DEVELOPMENT REVIEW BOARD
SUPPLEMENTAL SUBMITTAL

PROJECT NO. PR-2019-002651
Application No. SD-2019-00133

SUBMITTAL DESCRIPTION: Revised page 2 of plat, Response to comments (Hydrology & transportation), additional surveys & exhibits

DRB Project Number: 2019-002651
Sunport Park (Plat of Parcel 2-A)

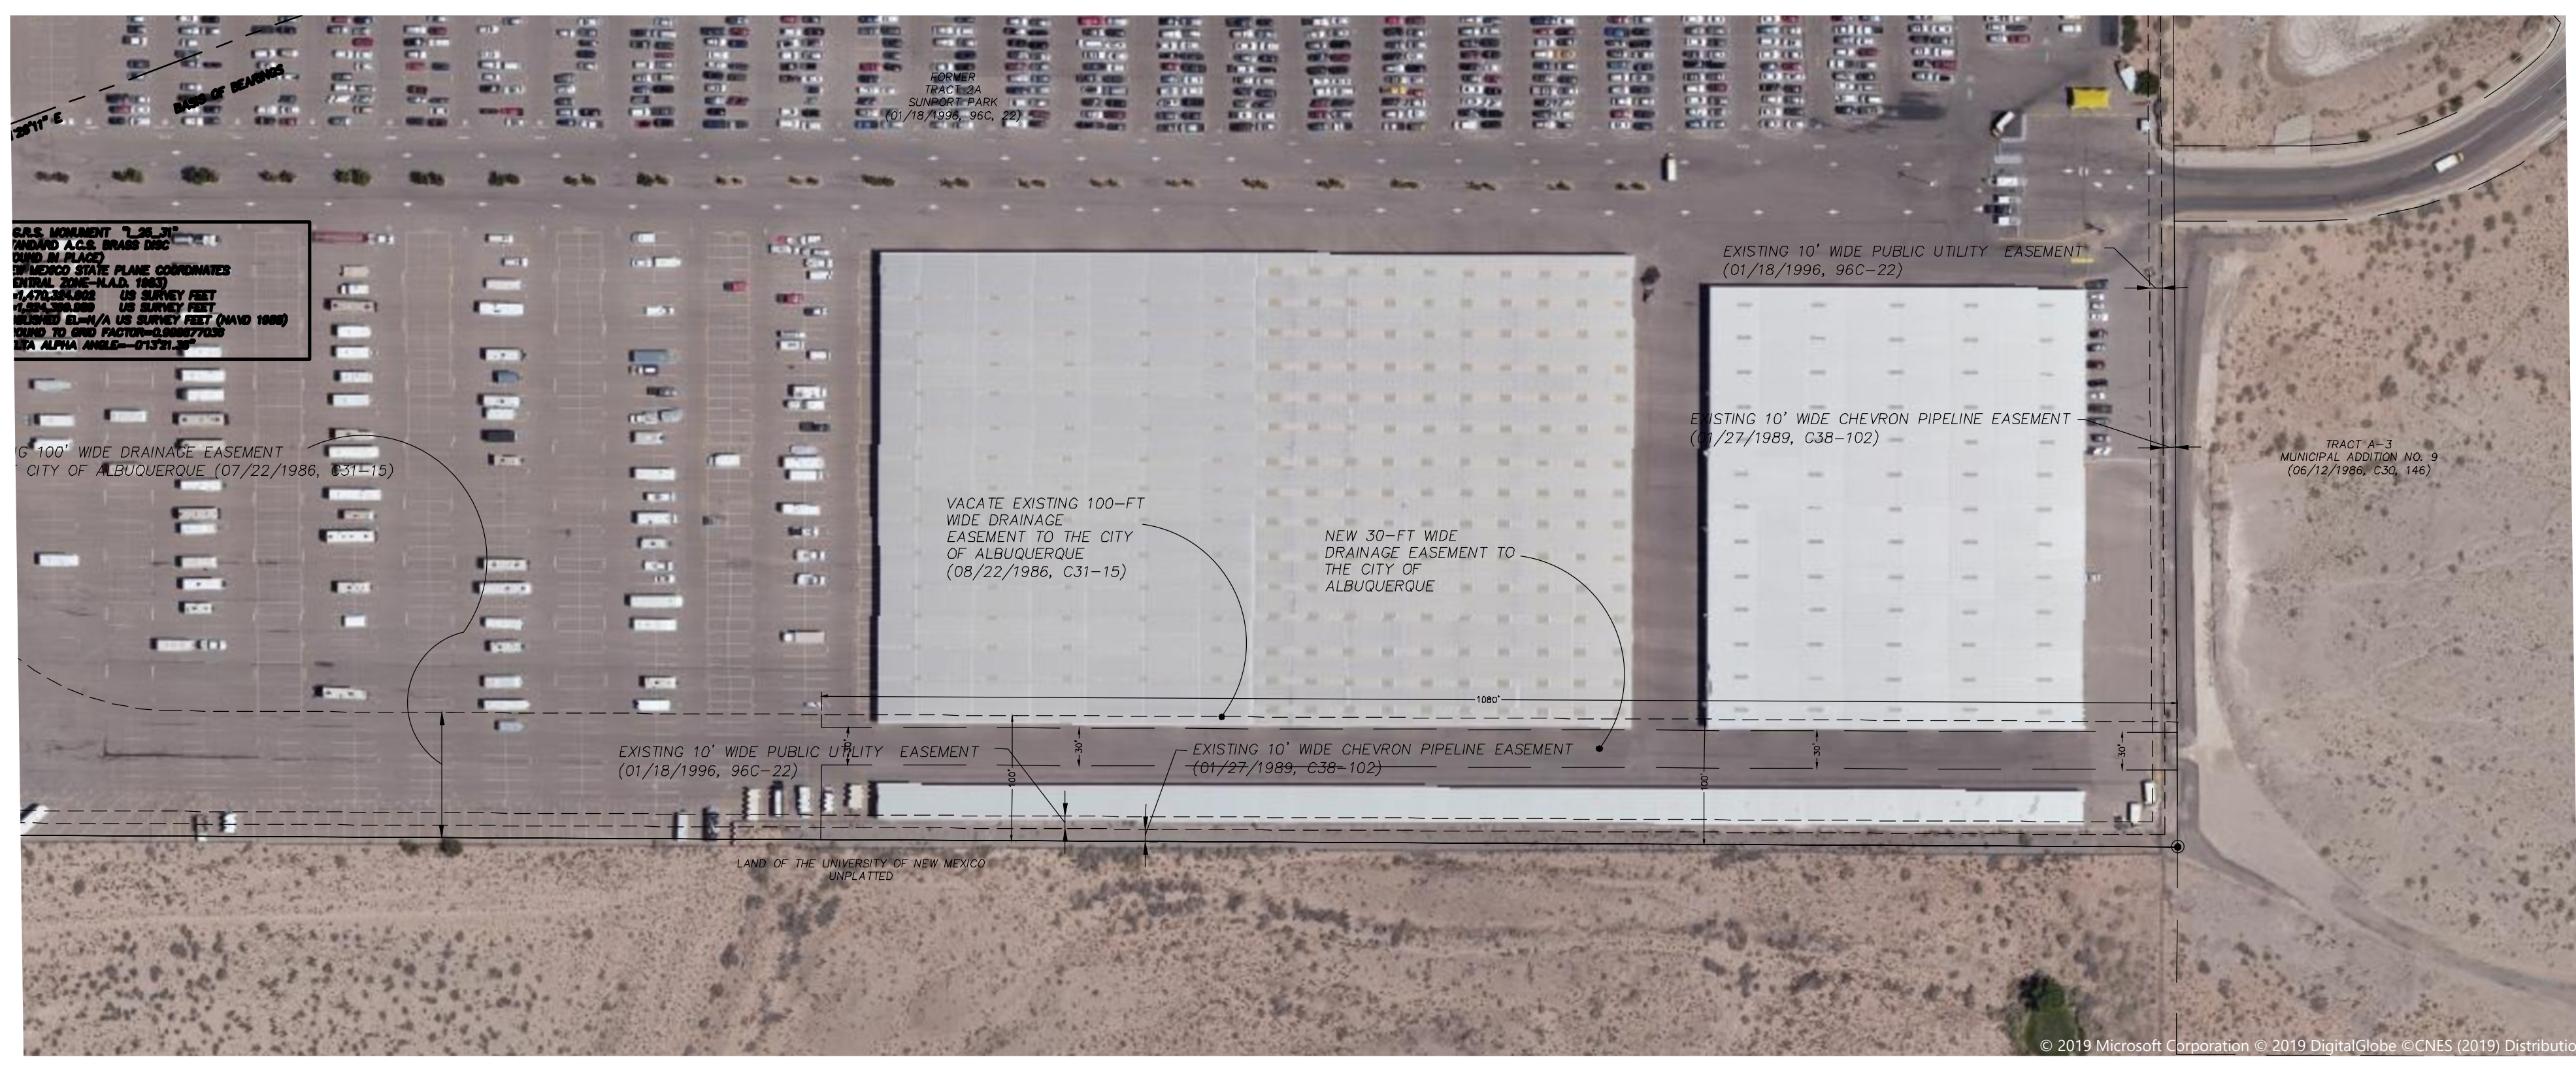
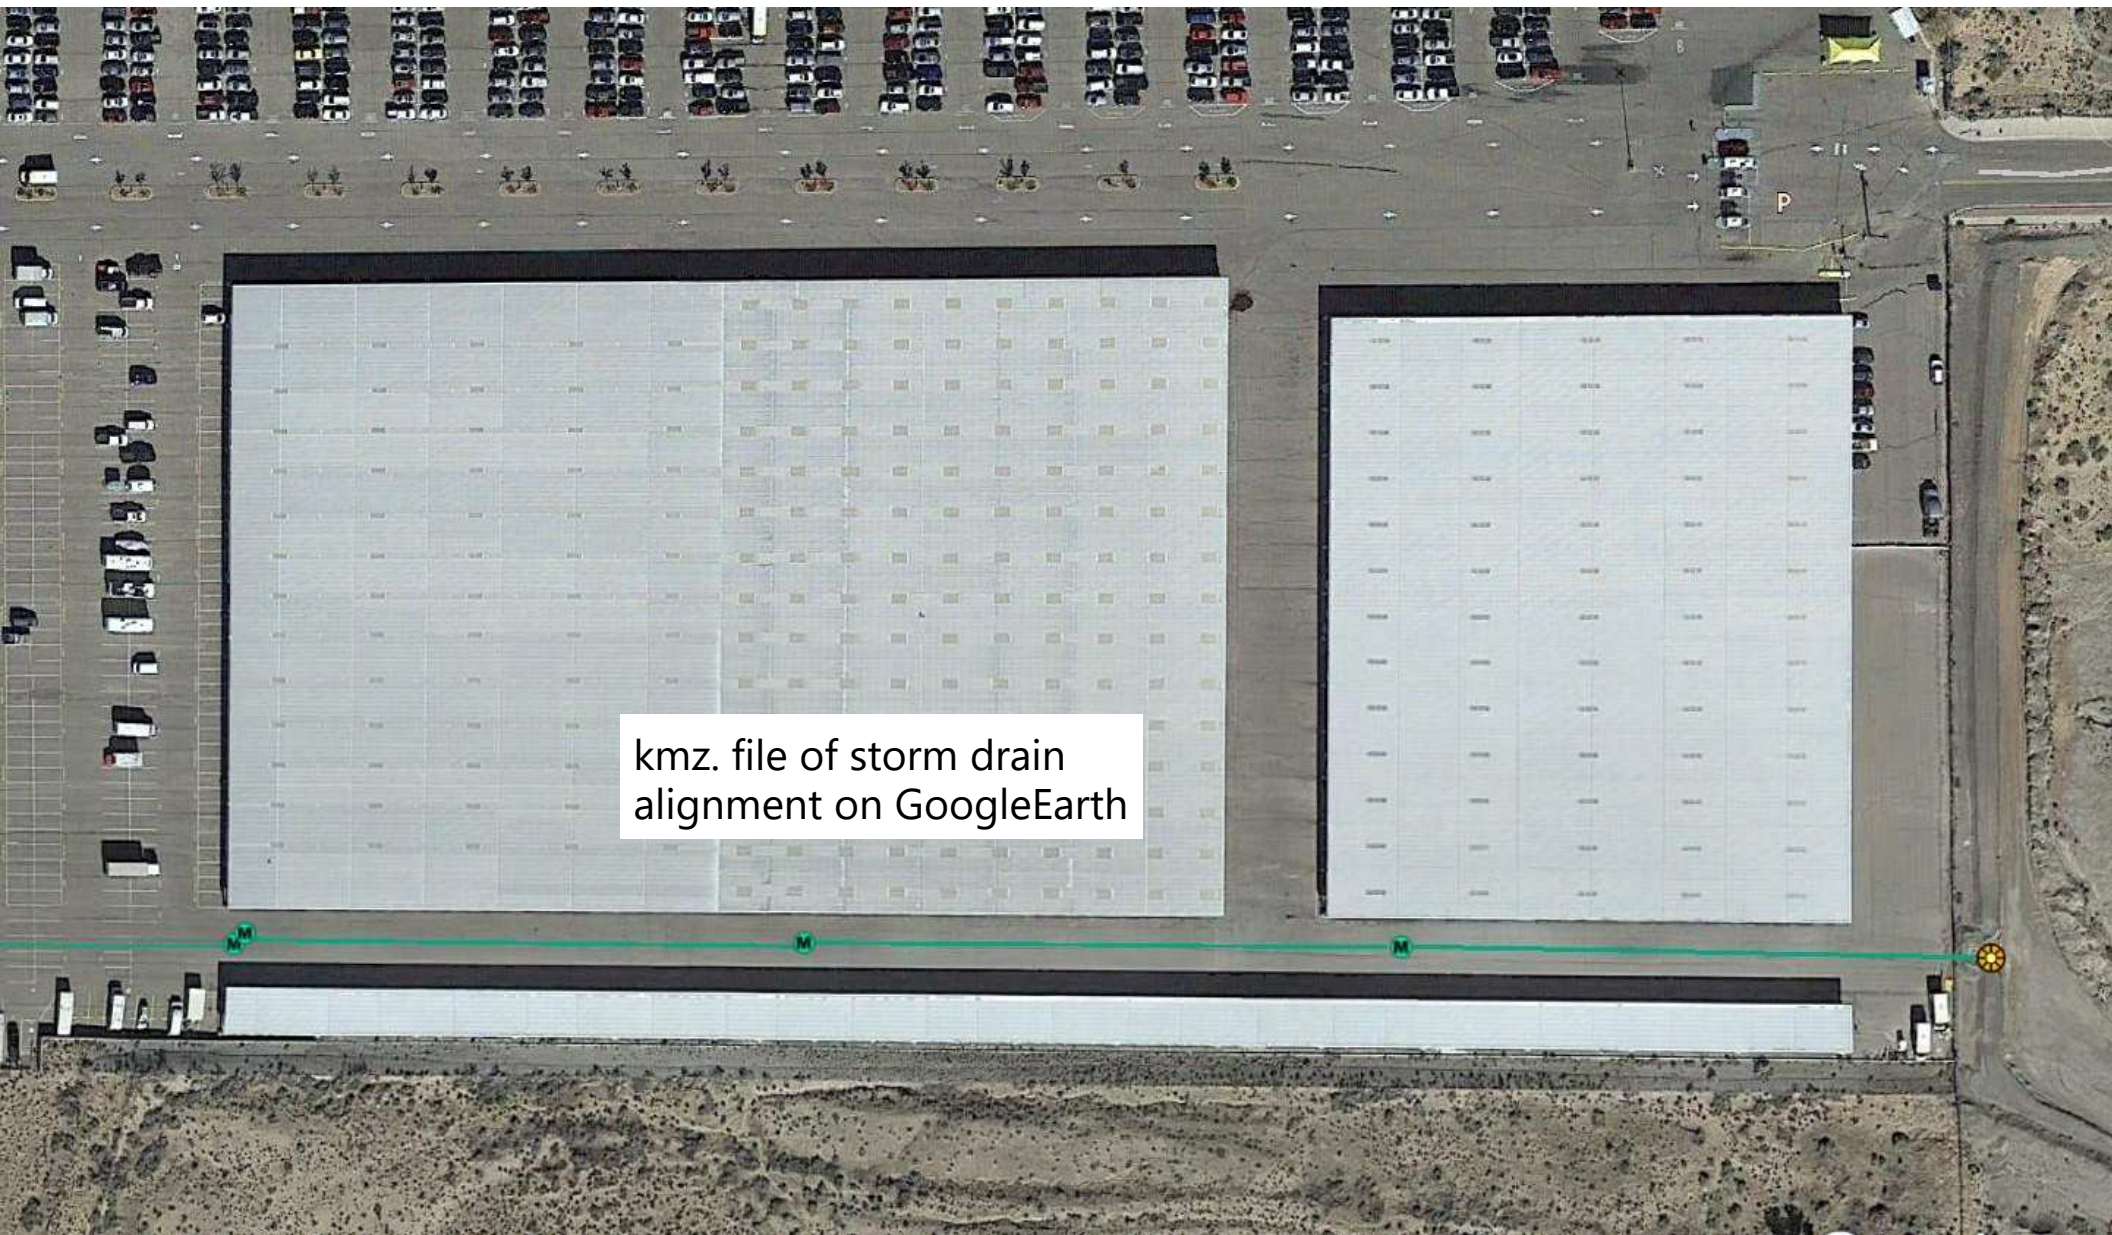
- Provide an exhibit, per the DPM Ch.22.6.C.2., showing the required drainage easement (or ROW width) in the NE corner, include the building location.
Exhibit included with the resubmittal details the proposed ROW width.

TITLE: **UNIVERSITY BLVD BIKEWAYS - PHASE 2**
 PLAN & PROFILE
 SUNPORT TRAIL STA 18+00 TO 25+00

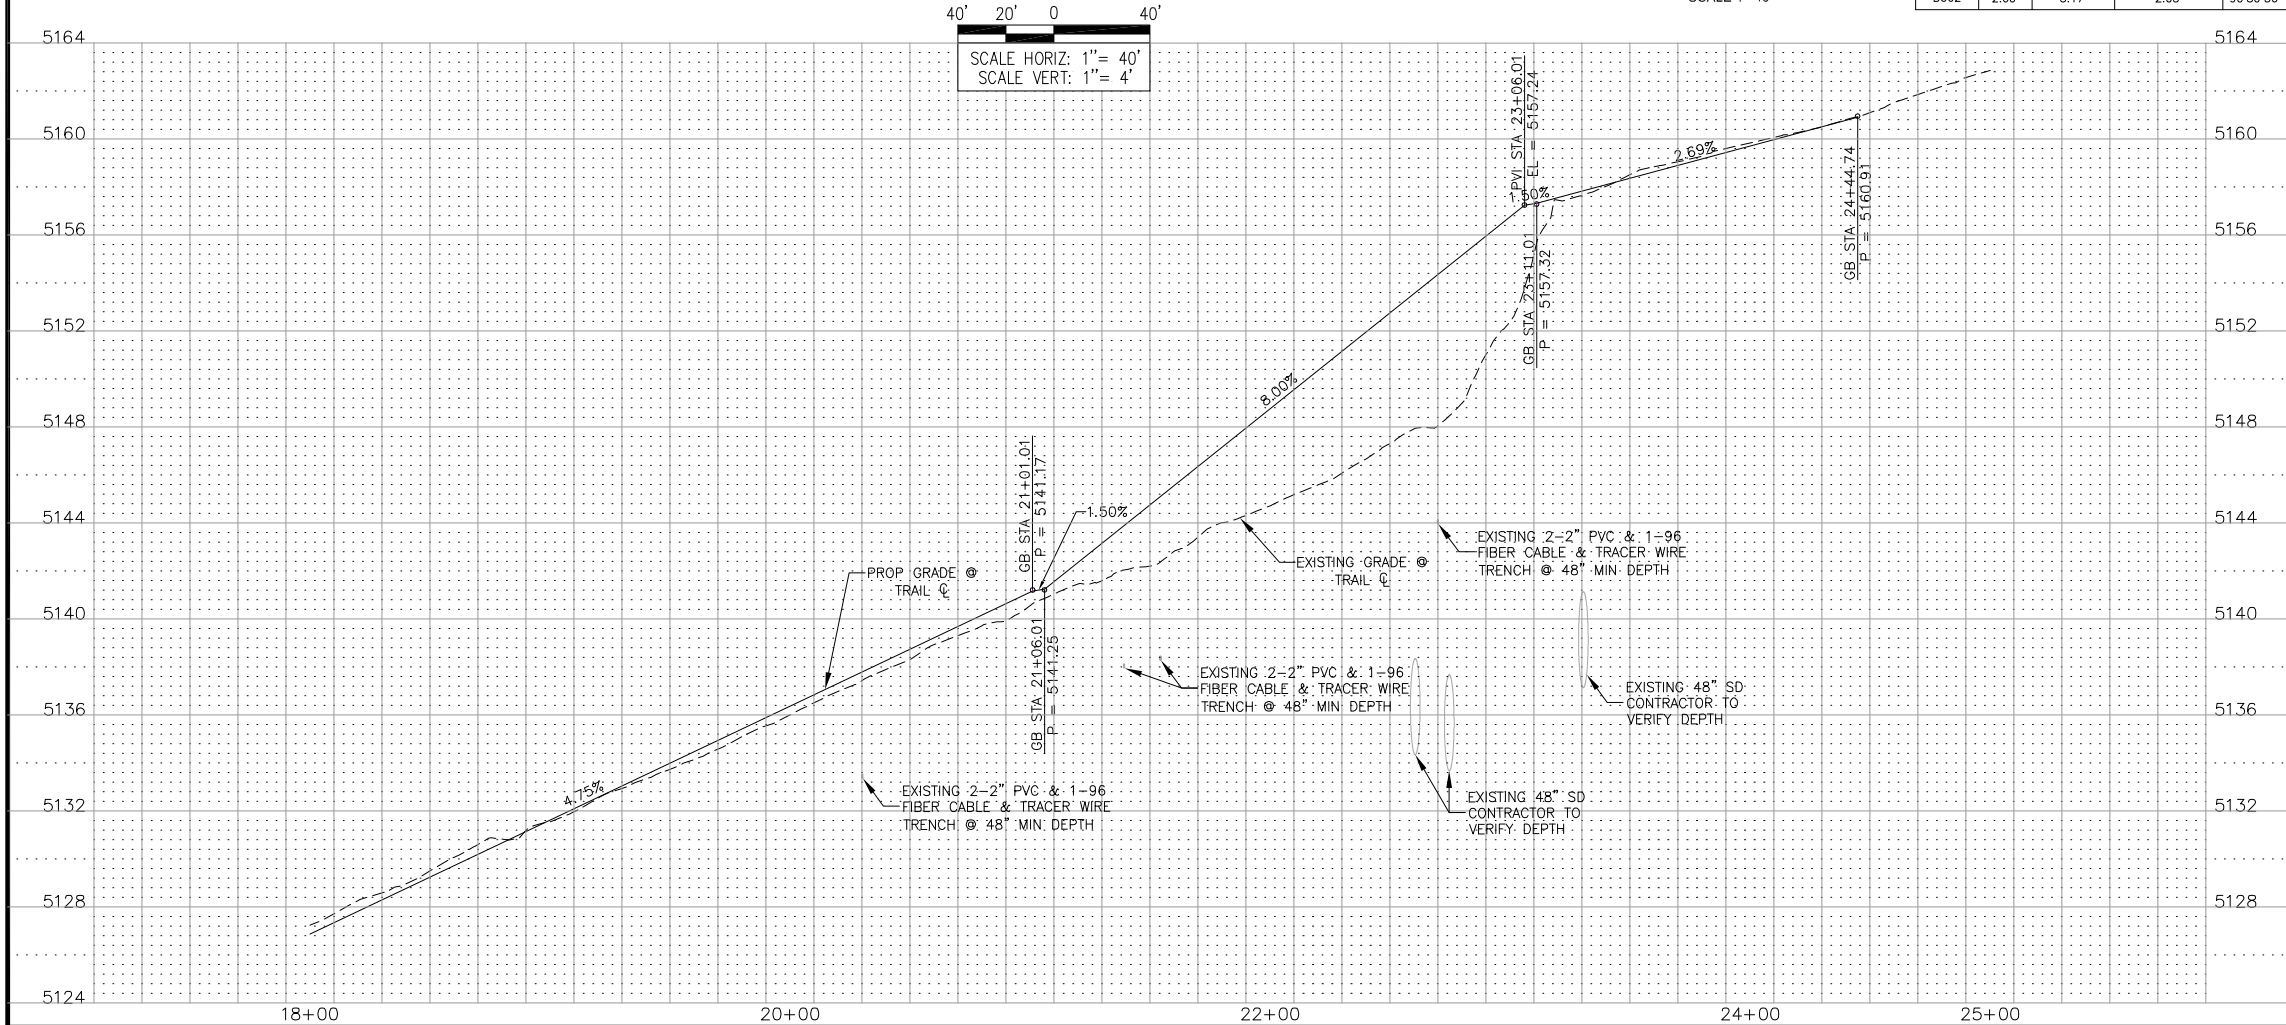
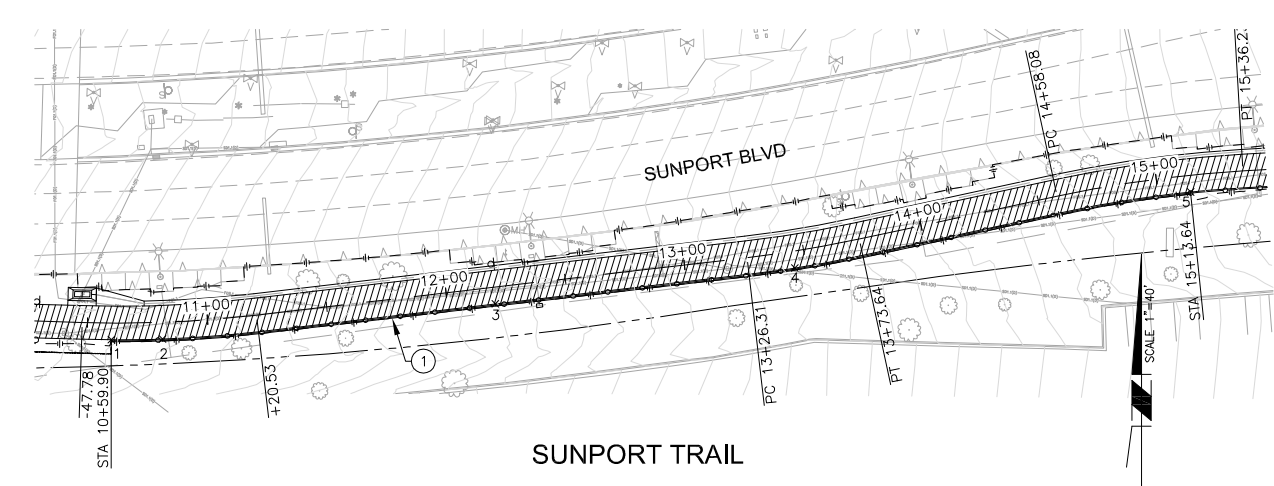
- Provide a topographic and features survey showing the exact locations (**vertical** and horizontal) of the existing public storm drain and the existing buildings/carports **in both the NE corner and south side** of the property.

See attached the DMD bikeway plans which details the public storm drain through the right-of-way. In addition, attached is the survey with the storm drain through the property on the south side in reference to the carport that was surveyed to confirm the aligned and the vacation and replat of the stormdrain easement.
